NORTH DAKOTA
DEPARTMENT OF TRANSPORTATION

Alternate Pipe Materials
Implementation Plan

November 2008

TRANSVERSE CENTERLINE PIPE BACKFILL FOR PIPES MORE THAN 4 FEET BELOW THE PROPOSED BASE

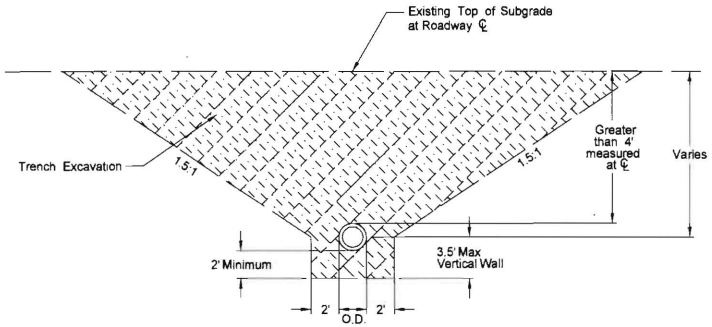
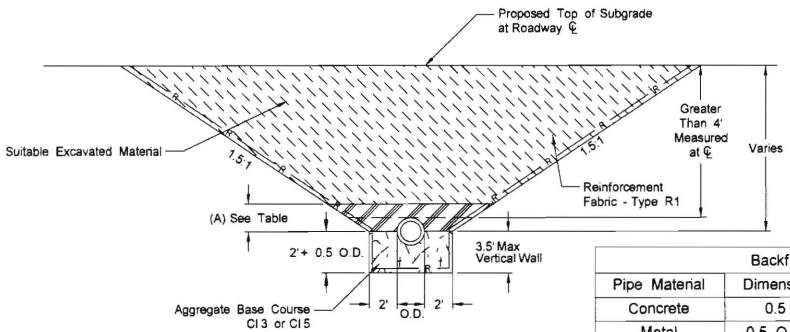
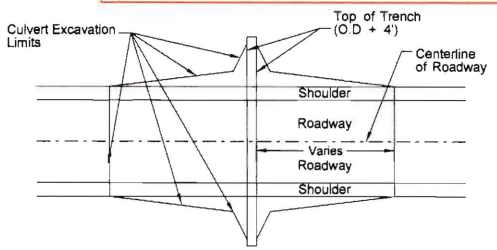
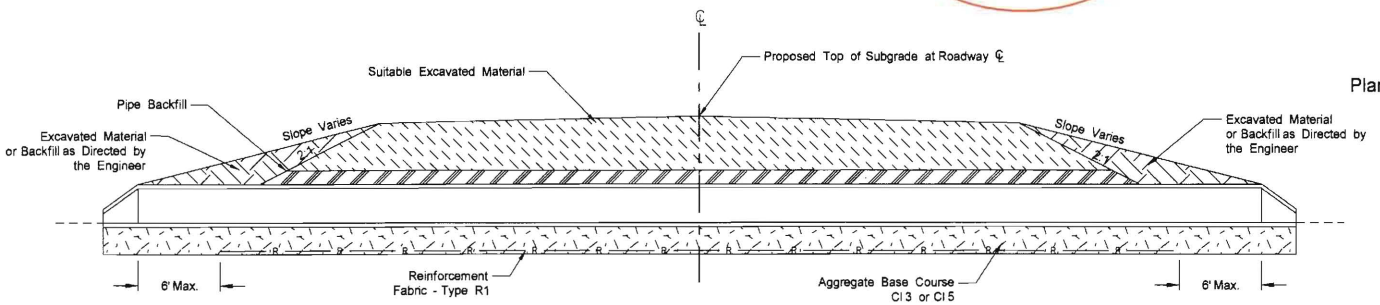
A third column was added to this table. This info was in a label pointing to the drawing.
Also added a reference to the note that defines Approved Backfill.

Note 1 (fabric installation) was removed as this is covered in section 709 of the Std Specs.

TRANSVERSE CENTERLINE PIPE BACKFILL FOR PIPES 4 FEET OR LESS BELOW THE PROPOSED BASE

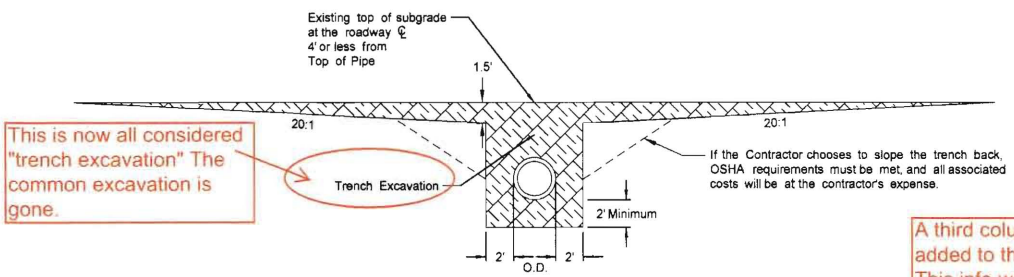
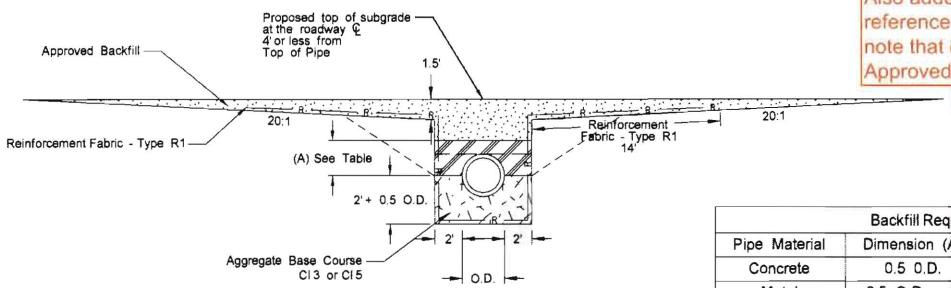
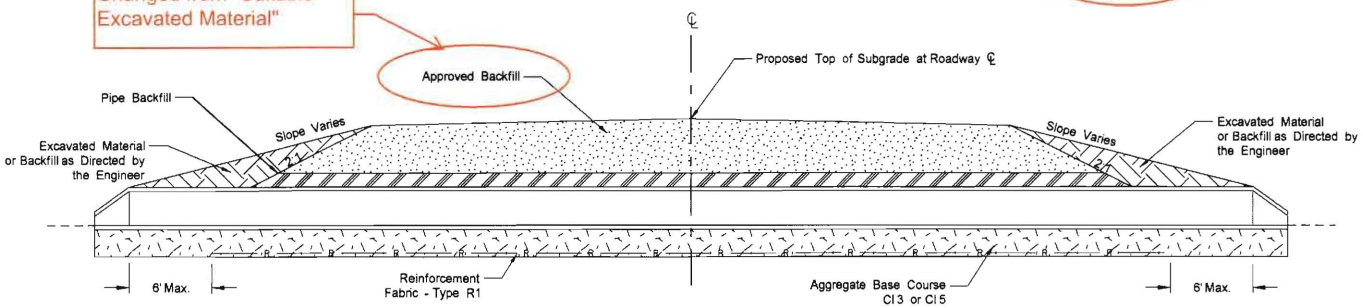
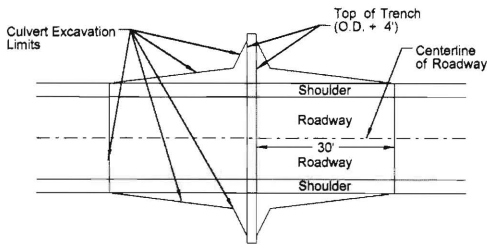
This is now all considered "trench excavation" The common excavation is gone.

A third column was added to this table. This info was in a label pointing to the drawing.
Also added a reference to the note that defines Approved Backfill.

Changed from "Suitable Excavated Material"

Note 1 (fabric installation) was removed as this is covered in section 709 of the Std Specs.

PIPE BACKFILL FOR STORM DRAIN UNDER ROADWAYS OF 40 MPH OR LESS AND PIPE NOT UNDER ROADWAY

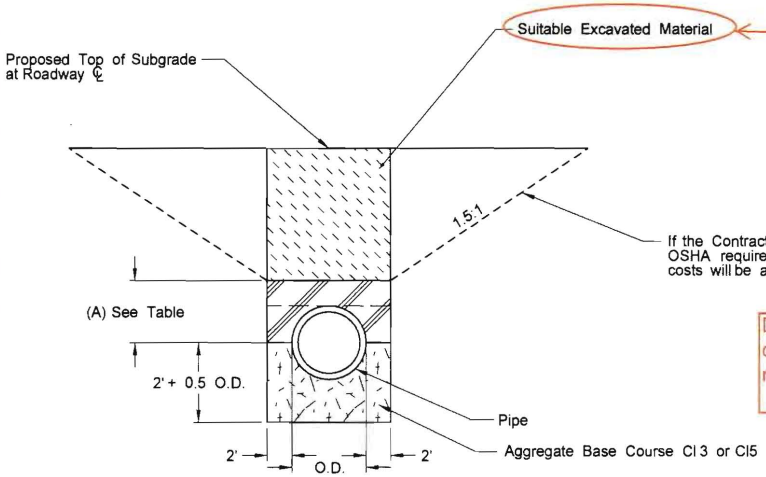
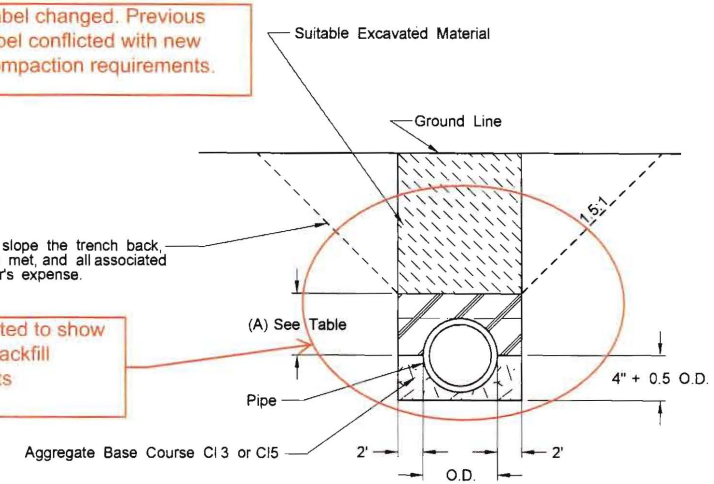
This detail was changed for consistency with other drawings. Surfacing was removed, the tapers were made optional, the backfill around the pipe was modified to reflect new practices.

Label changed. Previous label conflicted with new compaction requirements.

Detail adjusted to show change in backfill requirements

The plan view of the pipe installation was removed from this area. It only showed transverse installations under the roadway, which is only 1 of 3 situations covered on this drawing. It also didn't provide any info that isn't available elsewhere on the drawing.

Table added

Old note removed and new notes added.

TRANSVERSE CENTERLINE FILL FOR NEW PIPE LAID ON EXISTING GROUND IN EMBANKEMENT AREAS

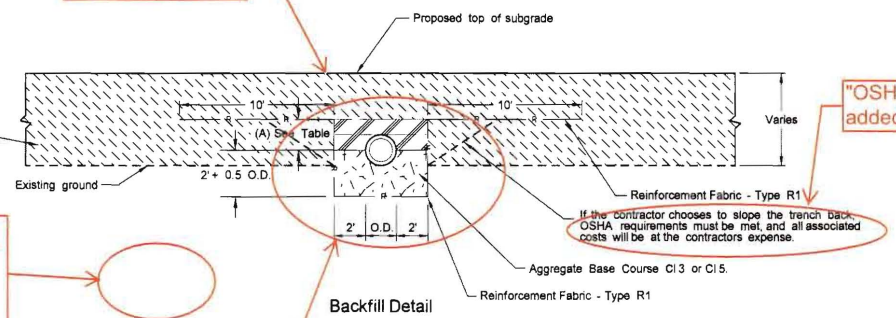
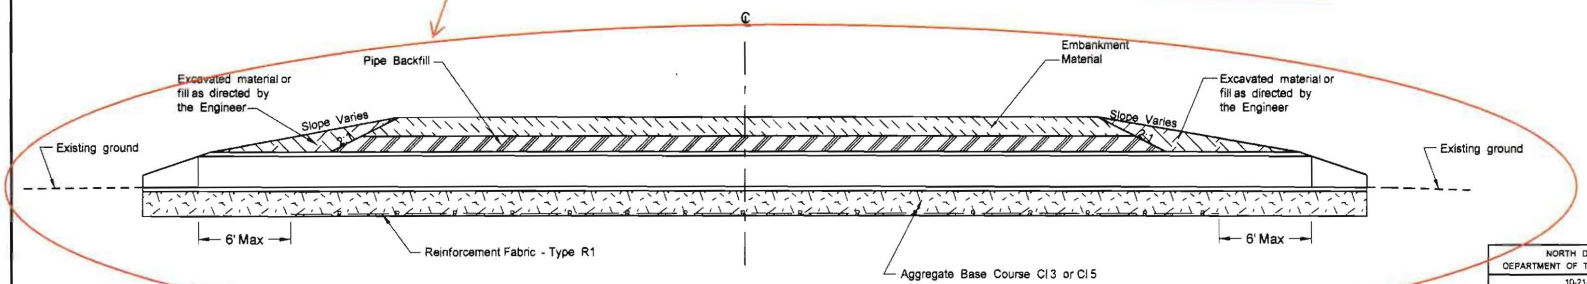
Changed to "Embankment Material" to avoid confusion with material placed on inslopes

Surfacing removed for consistency

"OSHA" note added

"Excavate a minimum of 2' below the bottom of the pipe." note was removed. This doesn't appear on other drawings and dimension in detail shows depth of fill.

Modified for consistency with other drawings

Old notes removed and new notes added

Table added

Modified for updates to backfill layers in detail above
